RE: Wemco CF3 10x8 City of Crest Hill Arthur Ave Water Pump
Serial Number: 85345-1-1
Customer Reference Order #: N/A
Kennedy Industries #: 128884

Attached are photos with descriptions of the parts in need of repair or replacement. If you have any questions, please do not hesitate to contact us.

MECHANICAL SEAL

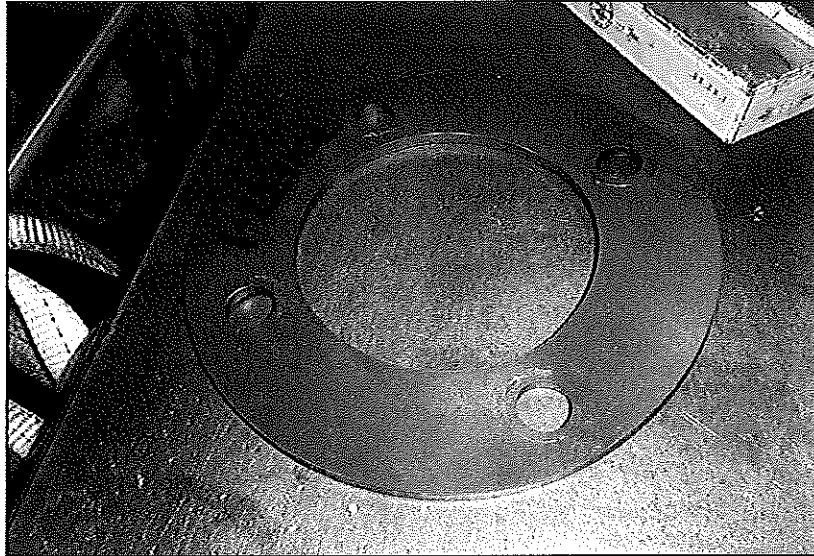
- Mechanical Seal is heavily worn.
- Mechanical Seal will be replaced with new OEM Mechanical Seal.
